## FINAL DEVELOPMENT PLAN APPLICATION

RE: Project Science Blvd Franklin Peak  
Final Development Plan

**Date:** April 2, 2018  
**Re:** Franklin Peak - Science Blvd.  
Final Development Plan

### PLANNING AND DEVELOPMENT STAFF REPORT

DRAWING NUMBER:  
1 / 1

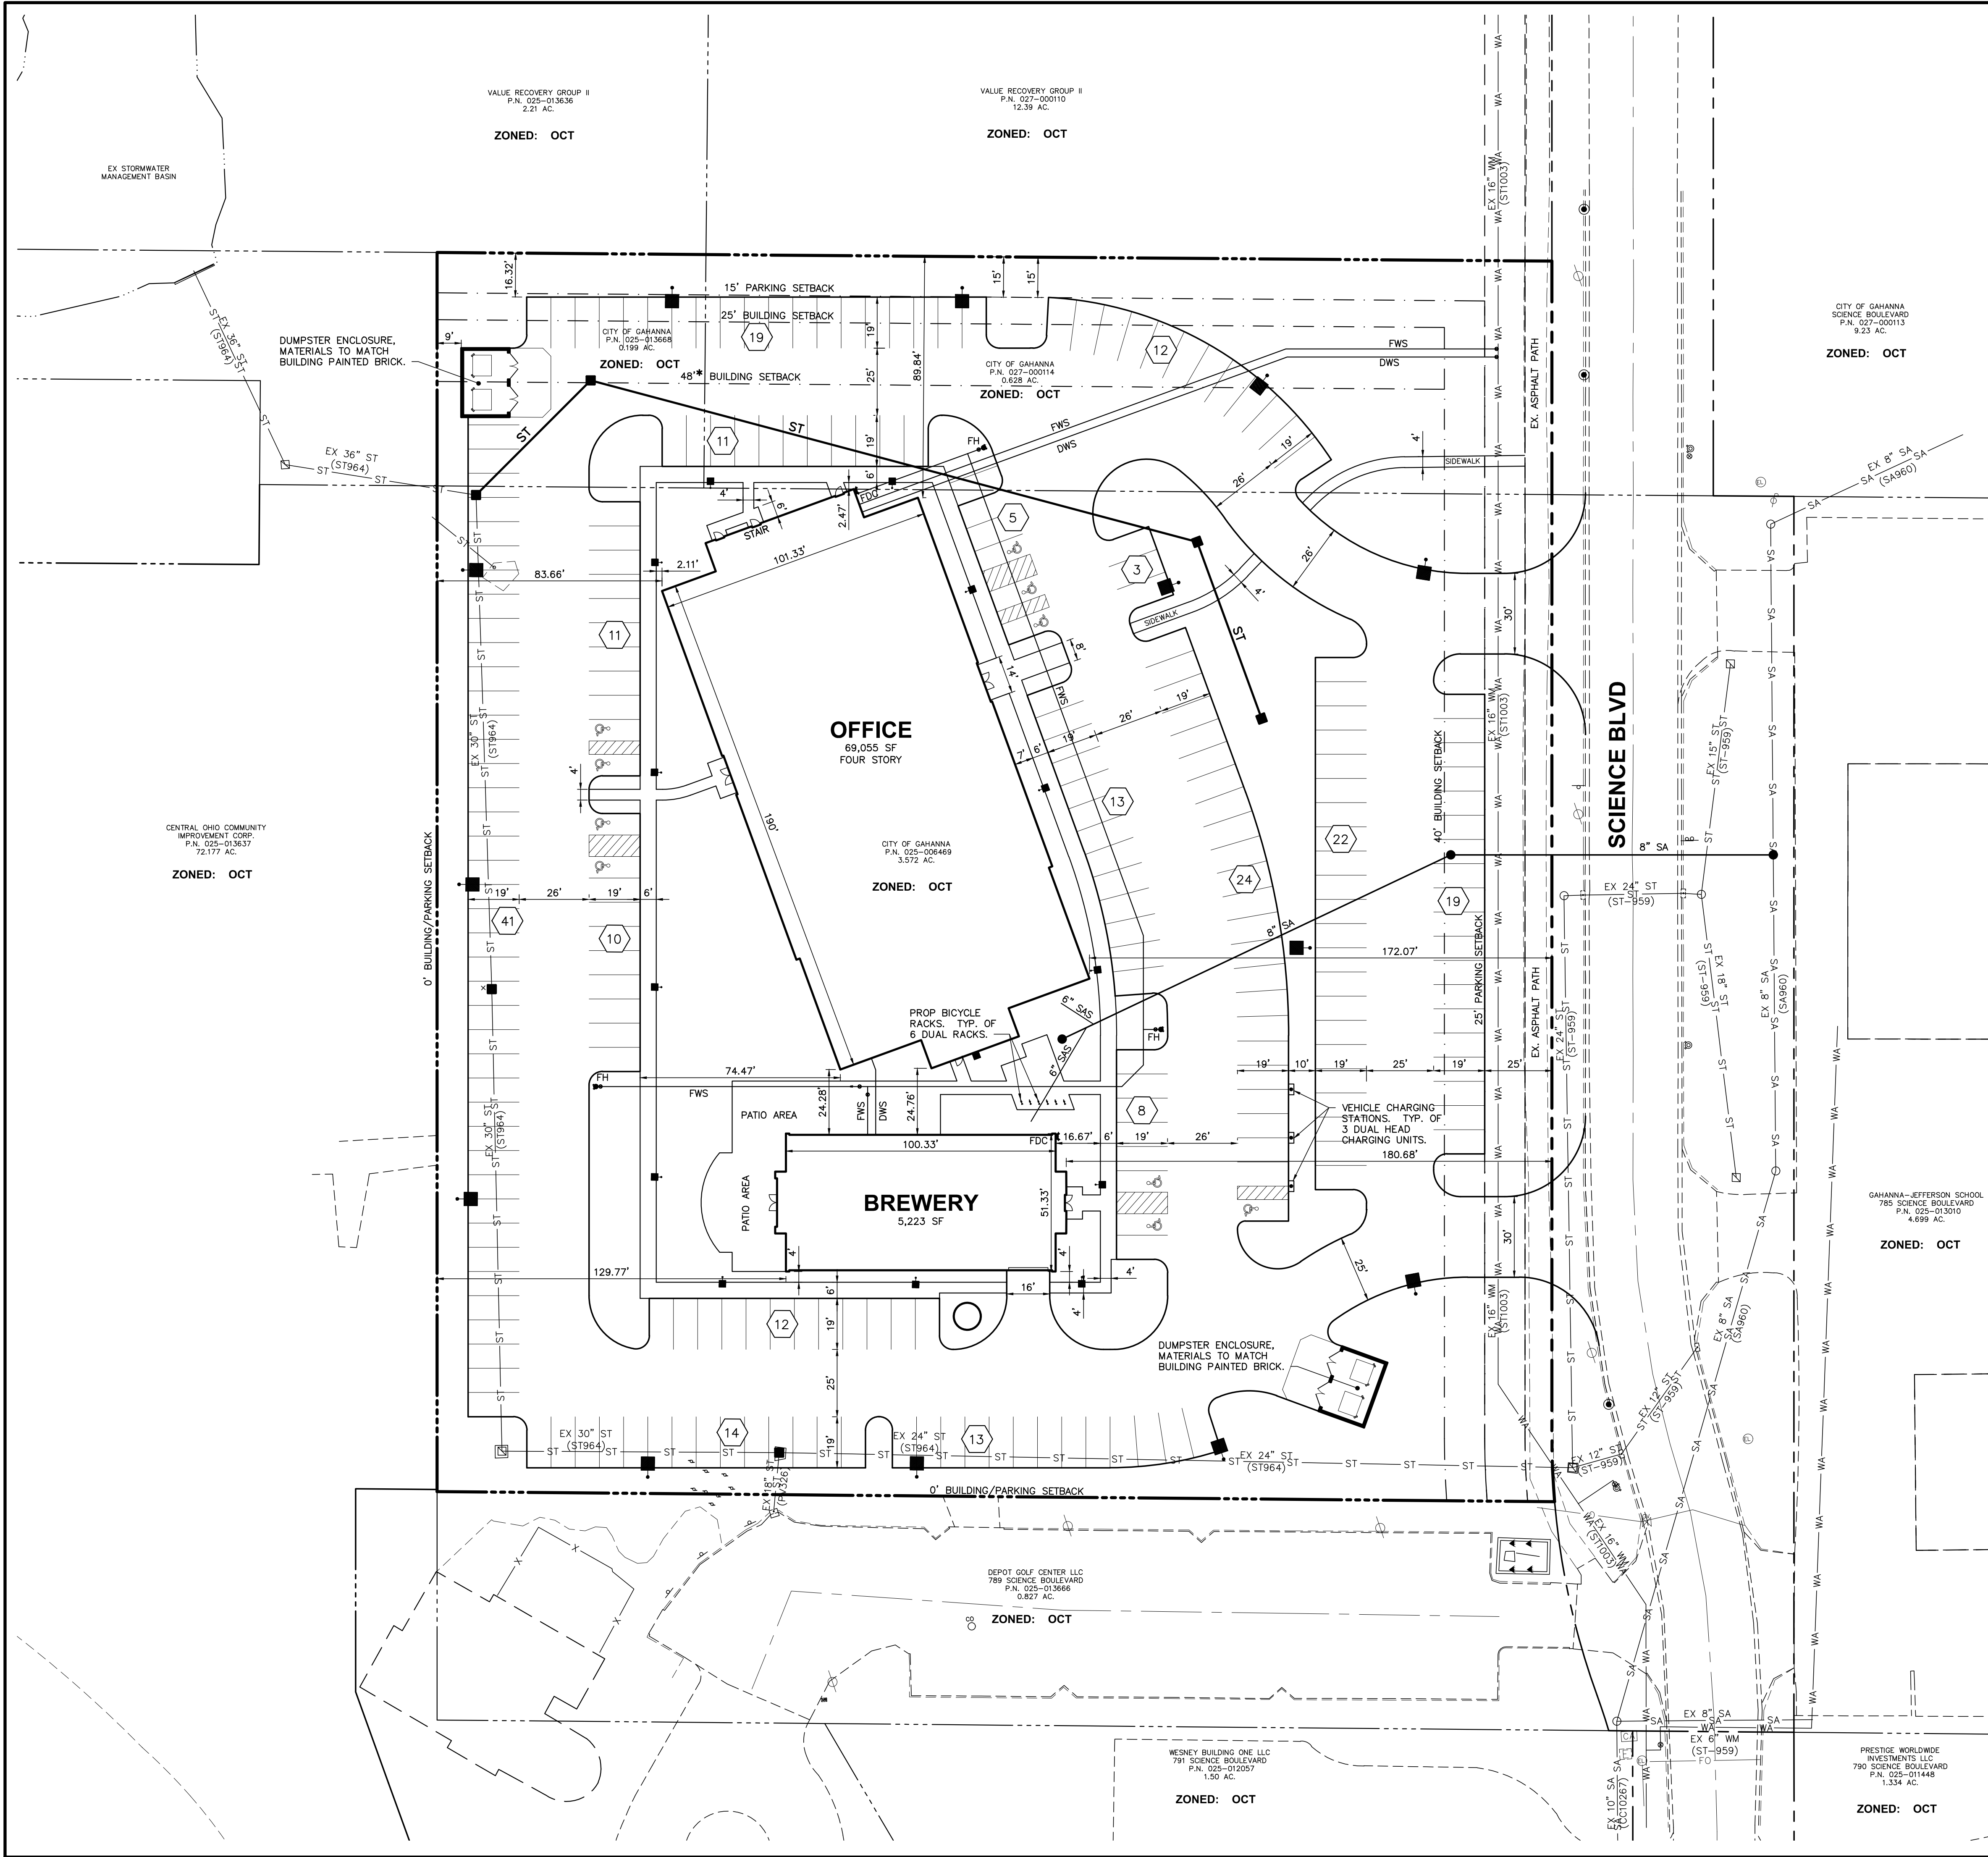
*6. The parking calculations provided on the Final Development Plan Sheet 1 indicate the brewery requires one space per 150 square feet. The use of a brewery is most similar to manufacturing. Therefore, the required parking would be one space per employee on the largest shift plus one space per business vehicle normally on the premises. Please revise accordingly.*

**Per phone conversation with Mr. Blackford on March 29, 2018, brewery parking count will be per "Restaurant Partial Service Over 5 Tables" which requires 1 parking space per 150 sq.ft.**

SITE LANDSCAPE PLAN

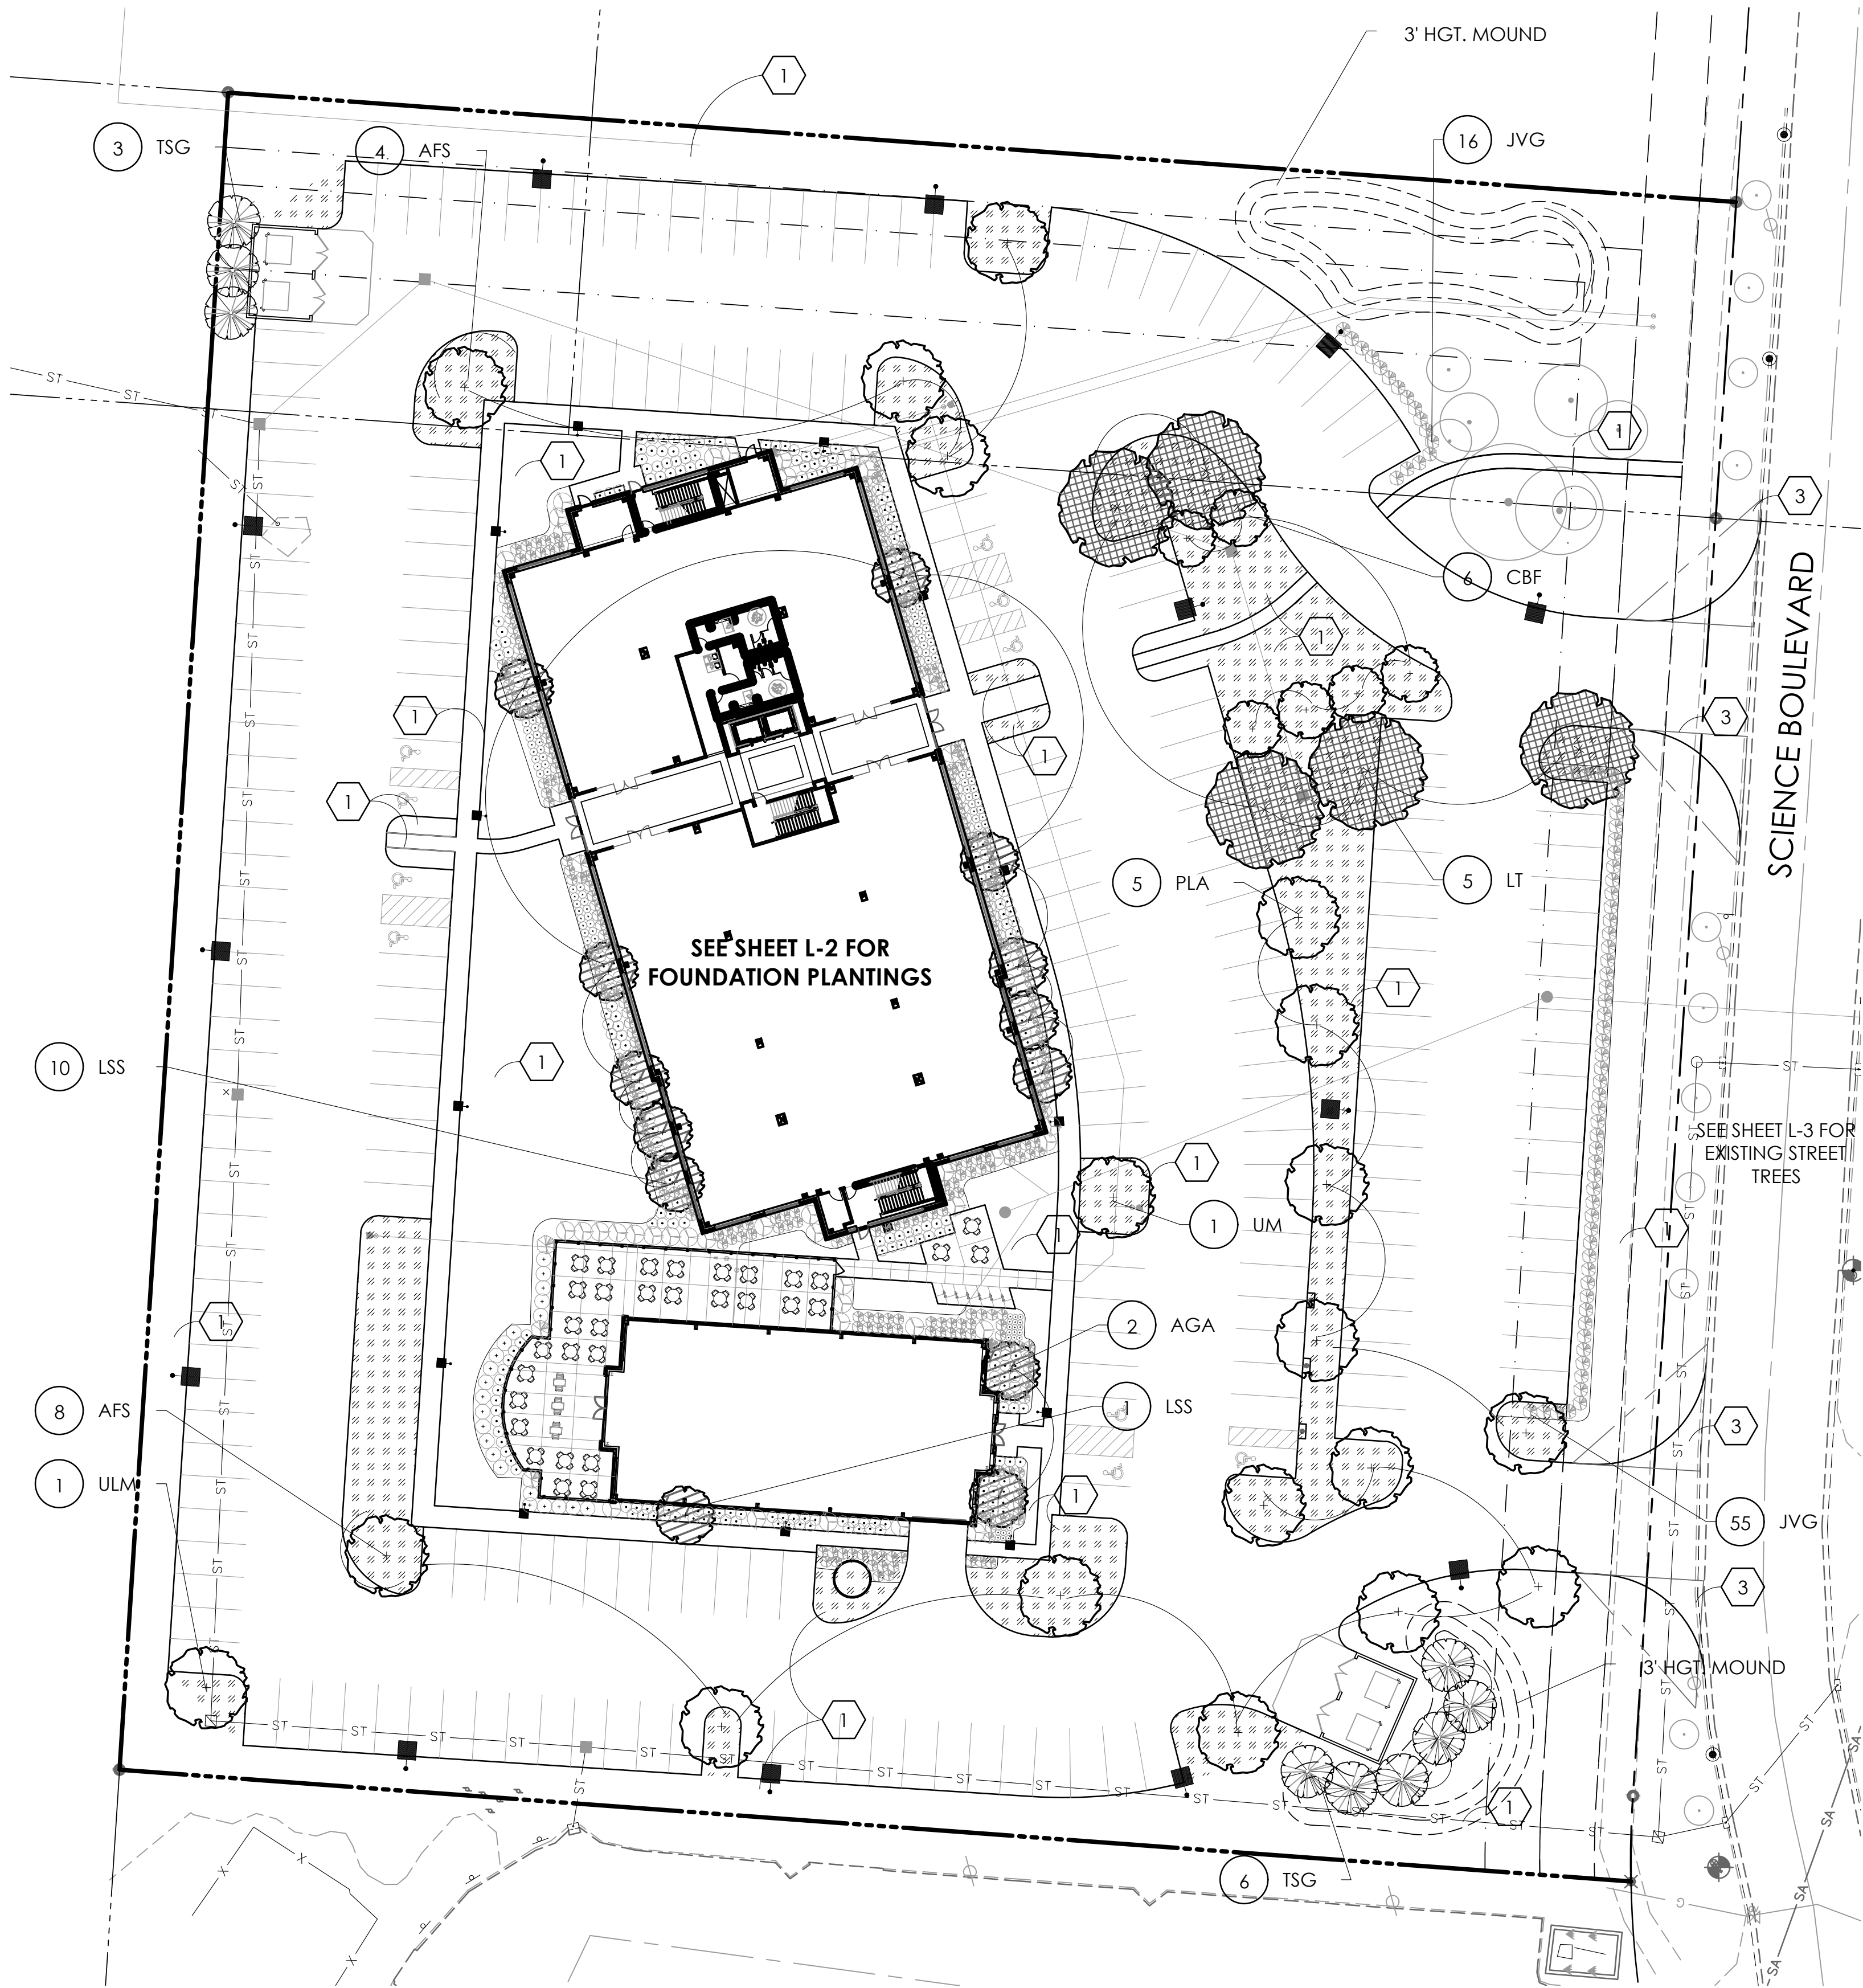
3. *I feel that this is over planted, and that will be an issue for the owner to deal with in the future. The other concerns that I saw was that the street trees are on the drawing but not listed as to what type of tree. The other concern is that we are keeping the site triangle open at the entrances? Per Rob Wendling*

**Existing street trees omitted in site triangles, of which the species is listed on sheet L-3. Tree calculations have been adjusted per Community Development response and site plantings have been reduced**
